Product Change Notification / SYST-29TDLI162

ERRATA - dsPIC33CK256MP508 Family Silicon Errata and Data Sheet Clarification Errata Document Revision

Description of Change: Added data sheet clarifications 1 (Electrical Characteristics) and 2 .(Special Features)

dsPIC33CK256MP508 Family Silicon Errata and Data Sheet Clarification

FIGURE 1-1: I/O RAMP

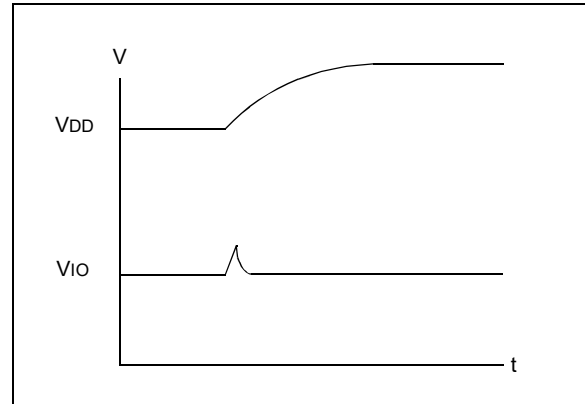
During a fast device power-up when the V_{DD} ramp is less than 4 mS, the I/O pins may drive up to 100 μ A current for a duration of up to 10 μ S (Figure 1-1).

1. Slow down the V_{DD} ramp time (greater than 4 mS for V_{DD} to ramp 0V to 3.3V).
2. Ensure the circuitry that is connected to the pins can endure this pulse.

Example applications affected may include complementary power switches, where a transient current shoot-through might occur. High-voltage applications with complementary switches should power the high-voltage 200 μ Sec later than powering the dsPIC[®] device to avoid the current shoot-through. This behavior is specific to each device and not affected by aging.
